Appendix I

Meeting/Project Name: East Urban Community (EUC) Phase 3 Area
 Community Design Plan (CDP)
 Technical Advisory Committee (TAC) Meeting #5

Comment Source	Comment Type	Commer	Comment	
Laurent Jolliet - Email Correspondence dated 2018-12-28	Preliminary Storm Comments - Major System	1	Peak flow and depth of flow along the major system for the 100-year storm are to be provided for all road sections of the major system to ensure compliance with Sewer Design Guidelines criteria.	Most areas in the NW and SW quadrants have been designed with either 100-year capture, or sufficient surface storage to fully contain the excess 100-year major system flows, such that the static storage may be up to 35 cm deep, and there is no dynamic overflow depth above the static storage during the 100-year storm. However, for those areas with negligible surface storage and less than 100-year capture, the maximum flow and flow depth along a typical road cross-section has been calculated as attached to demonstrate conformance with City of Ottawa standards. See Attachment A . Note that these areas include Mer Bleue Road (10-year capture, excess major system flows to external system), and any potentia

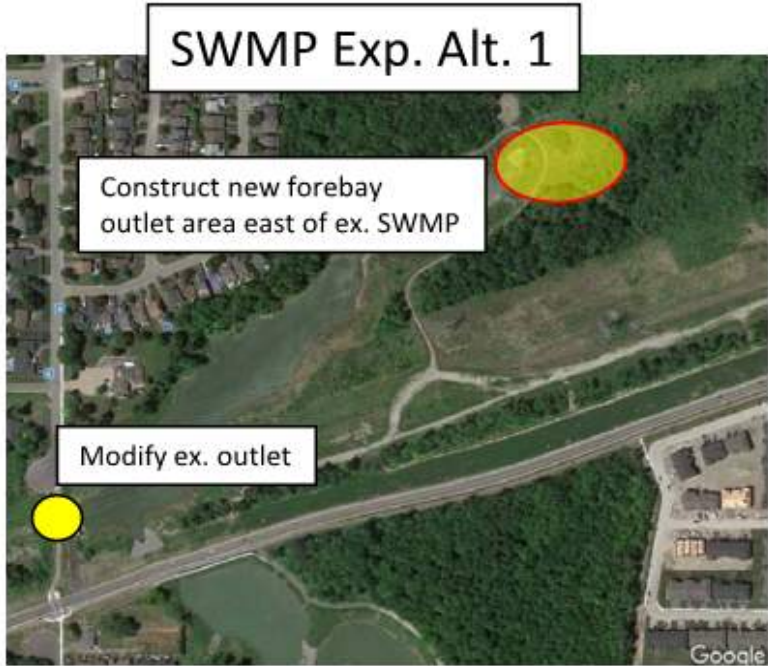
<p>IPU - Ted Cooper - Email Correspondence dated 2019-04-29</p>	<p>SWM Pond Expansion</p>	<p>42</p>	<p>The MSS identified the need to expand the existing EUC Pond 1. The MSS did not present / evaluate alternatives that were considered as to how / where the SWMP was to be expanded. The only approach presented included expansion of the SWMP into the woodlot surrounding the existing pond, part of which is subject to the City's Significant Woodland Guidelines. Application of the Significant Woodland Guidelines must follow the mitigation hierarchy outlined below, which lends itself well to the normal evaluation process requirements of MSSs / Class EAs previously approved by Council. As is outlined in the Guidelines, environmental reports must explicitly address how the mitigation hierarchy has been applied in the proposed development or site alteration.</p> <p><i>The mitigation hierarchy is a widely accepted approach in conservation and land use planning for guiding decisions on protection of the natural environment. It categorizes and prioritizes protective measures according to their general type and effectiveness:</i></p> <p><i>Priority 1 - Avoidance: redirection of the proposed action away from the natural feature.</i></p> <p><i>Priority 2 - Minimization: reduction of the magnitude of the proposed action, either in space, time, or both.</i></p> <p><i>Priority 3 - Mitigation: protection of the feature from the proposed action, through measures such as changes in design, physical barriers, and modified operating procedures.</i></p> <p><i>Priority 4 - Compensation: off-setting of the impacts through replacement of the feature and its ecological functions elsewhere, typically at a ratio greater than 1:1 to reflect the greater risks.</i></p> <p>The current draft of the MSS has focused entirely on Priority 4 – proposing compensation of only 0.5 ha of tree planting for every 1 ha of loss of woodland around EUC Pond 1. There will be a need to demonstrate why Priorities 1-3 cannot apply if there is a need to expand the SWM Pond into the Significant Woodlands at the perimeter of EUC Pond 1.</p>	<p>Noted. The attached memo from Kilgour (Attachment G) clarifies the extent of the significant woodland based on current City guidelines. Based on the new woodland definition and the updated predicted storm inflows (including exclusion of future development of the snow dump), a revised draft pond footprint was submitted for City review in June 2019. This footprint has been carried forward in the MSS.</p>

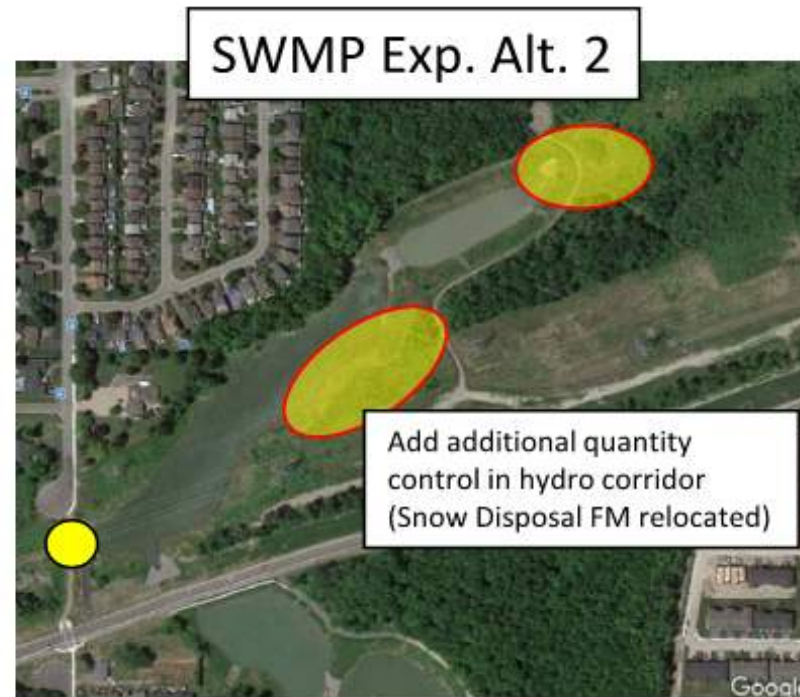
45 2) If additional quantity control is required beyond Alternative 1, expand existing SWMP into hydro corridor to the south;

Per the approved EUC Pond 1 design drawings, the Hydro One corridor is the location of the sediment management area for EUC Pond 1.

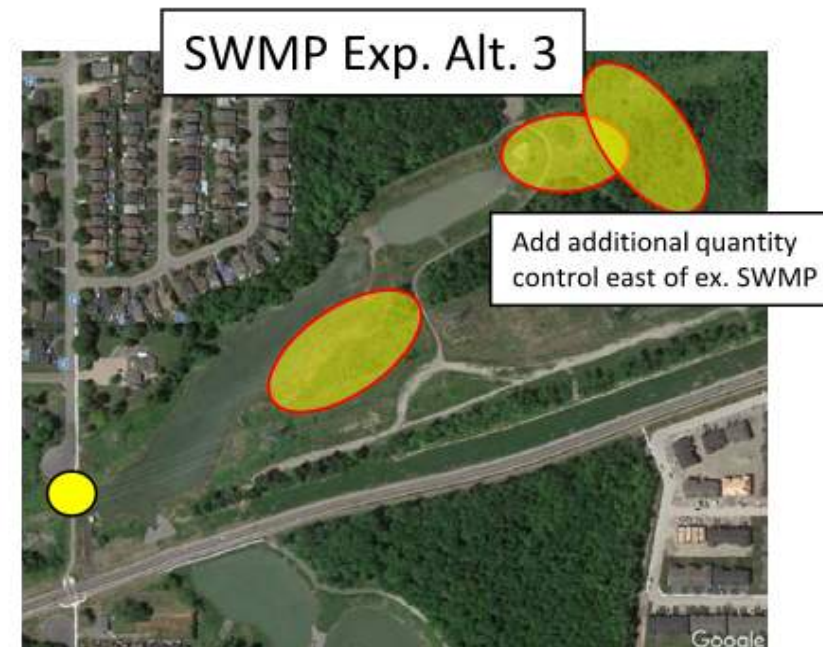
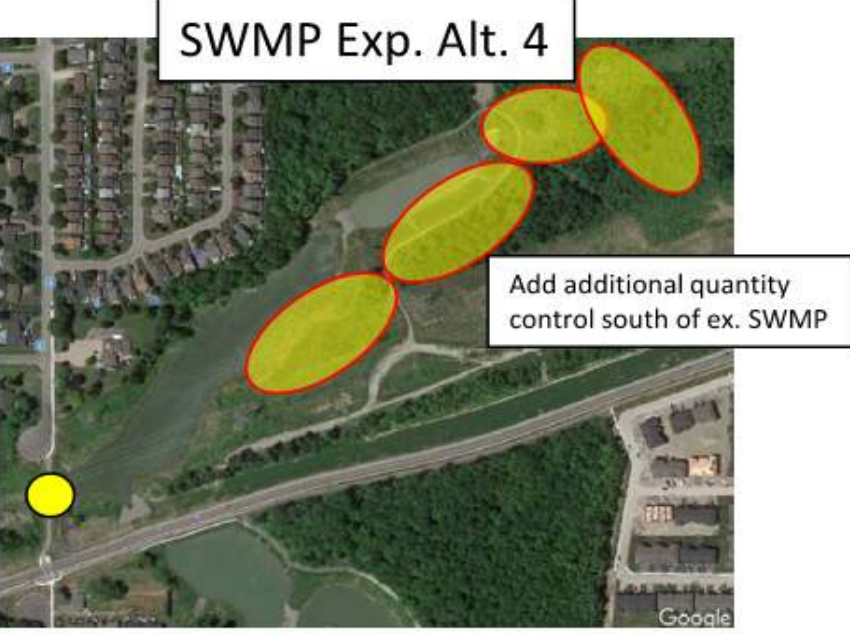
46 3) If additional quantity control is required beyond Alternative 2, expand SWMP to the east of the existing SWMP;

Noted. This option has not been pursued, as the pond footprint is considered appropriately sized in its current form. Additional expansion would encroach on the existing sediment management area or the proposed development lands within the CDP area.

DSEL Markup
Oct 4, 2019

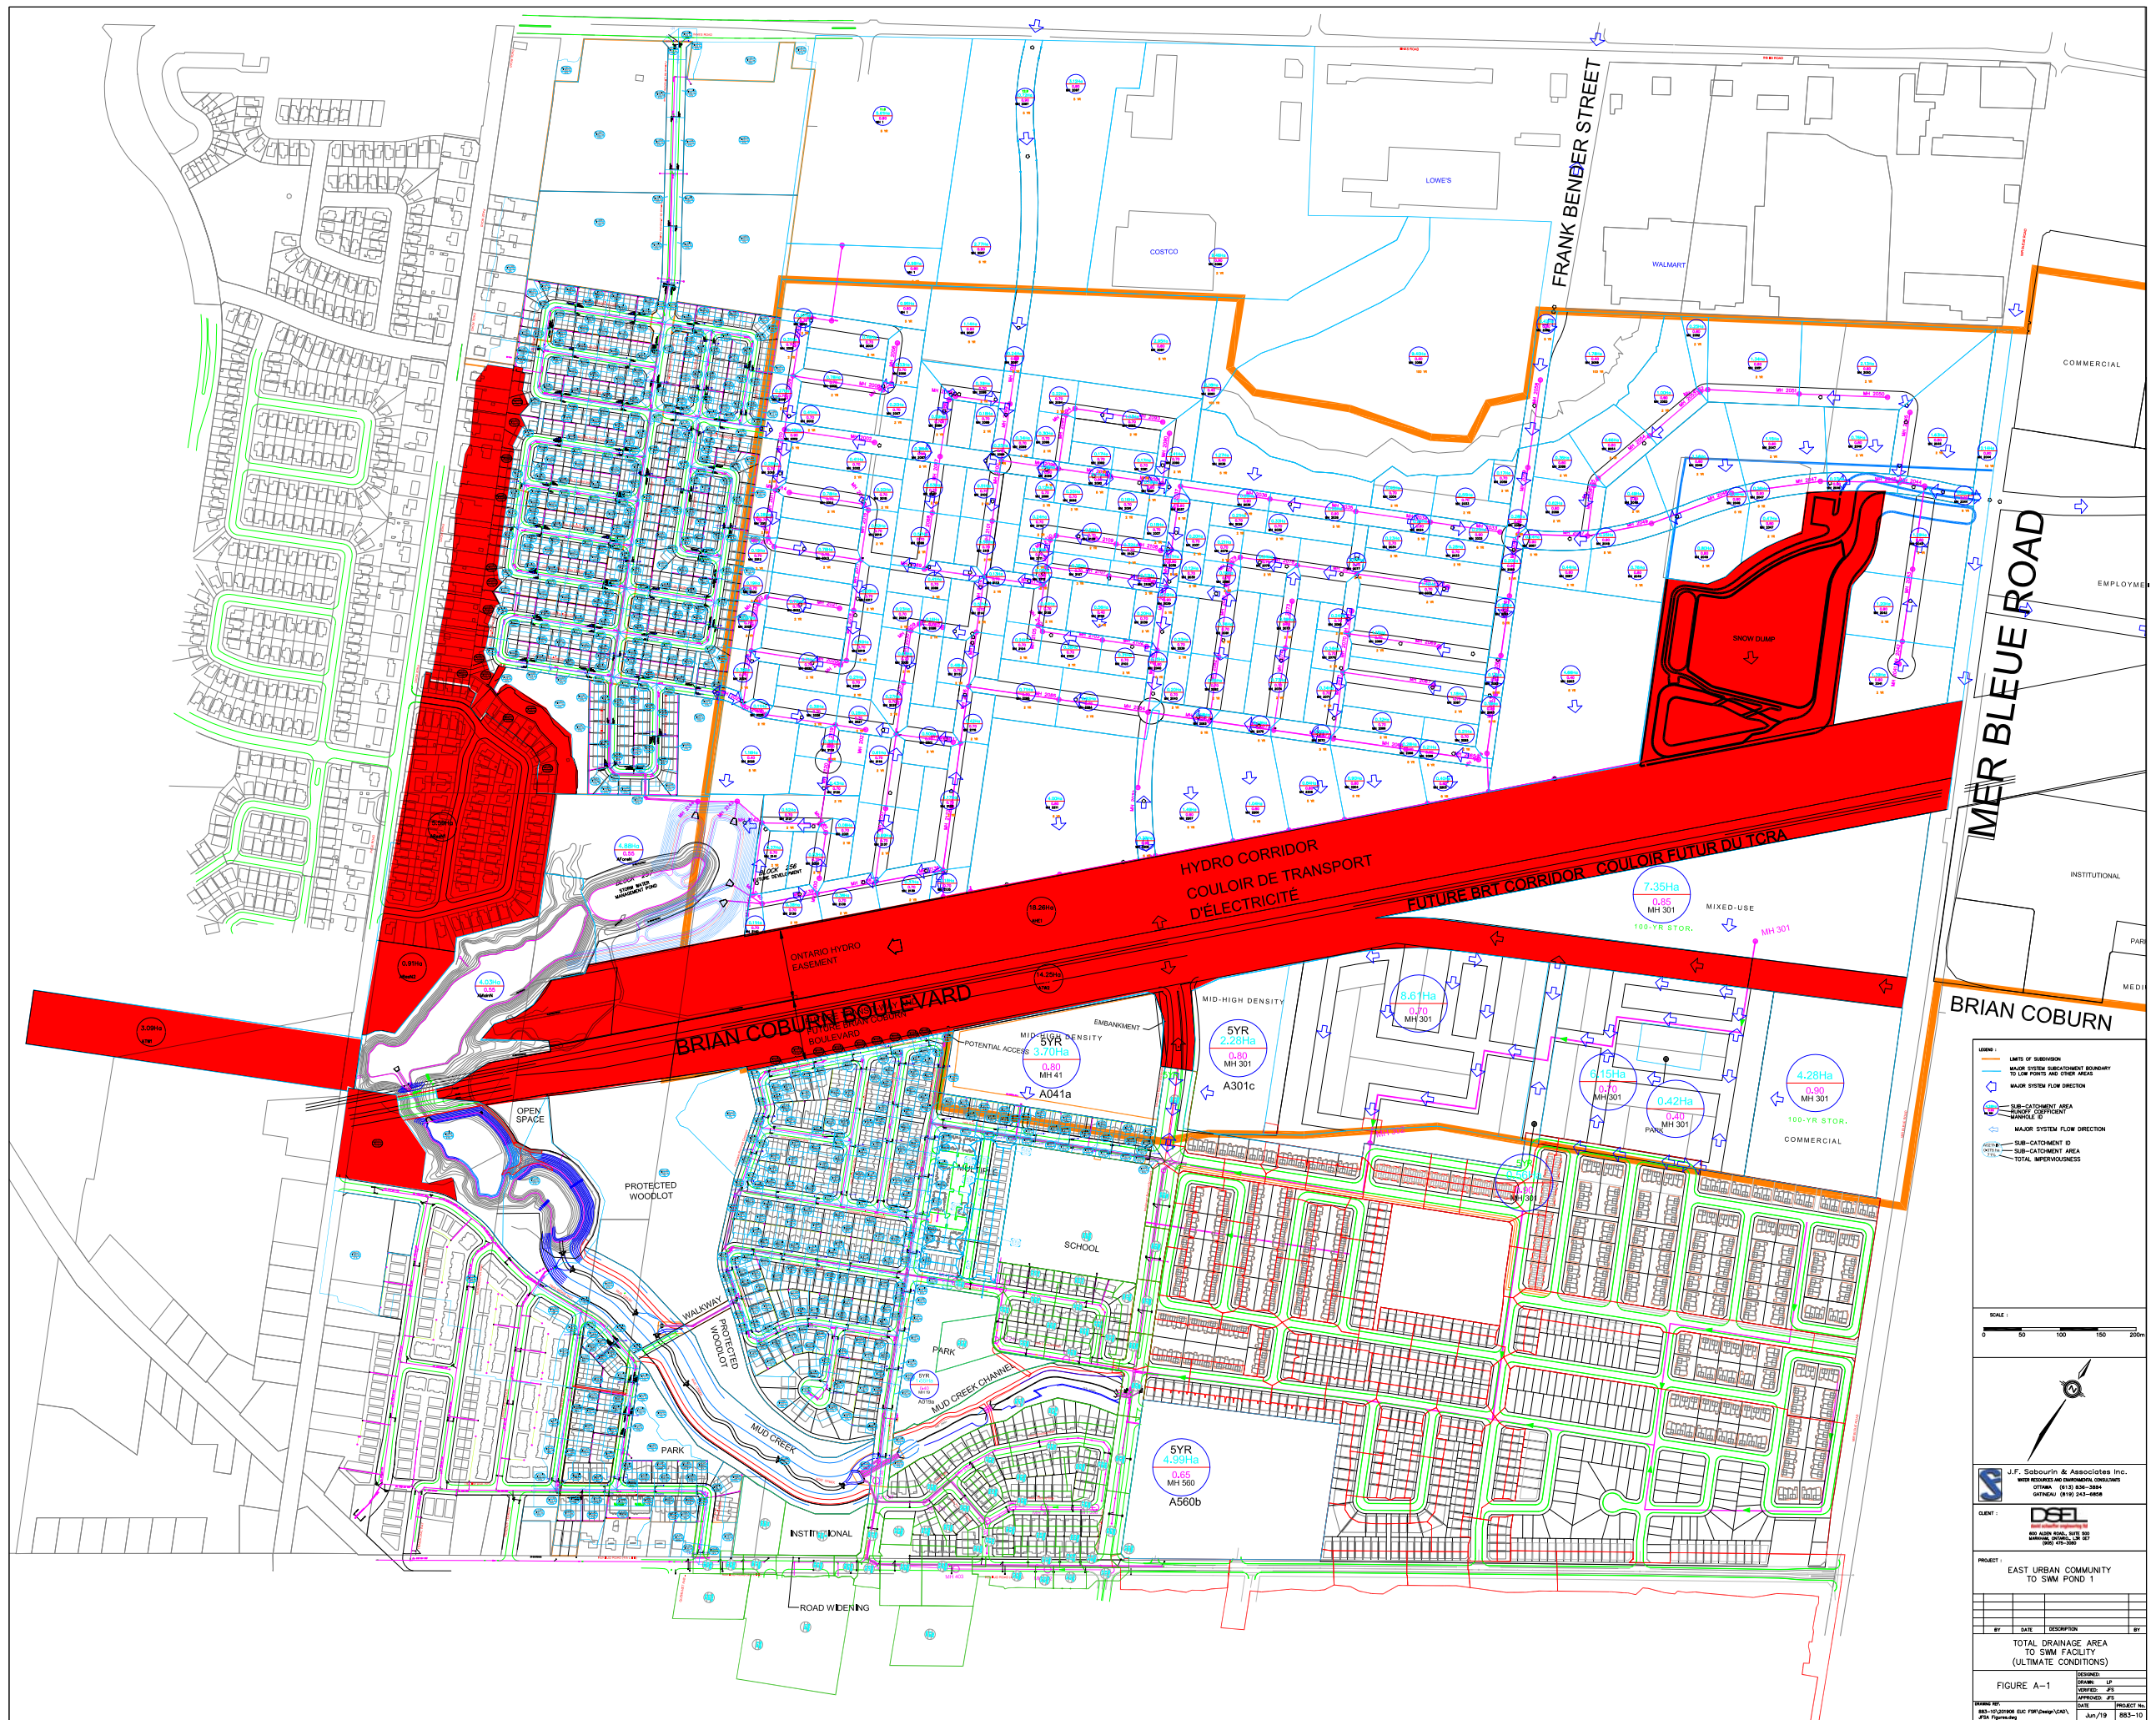
Areas draining directly to the main cells
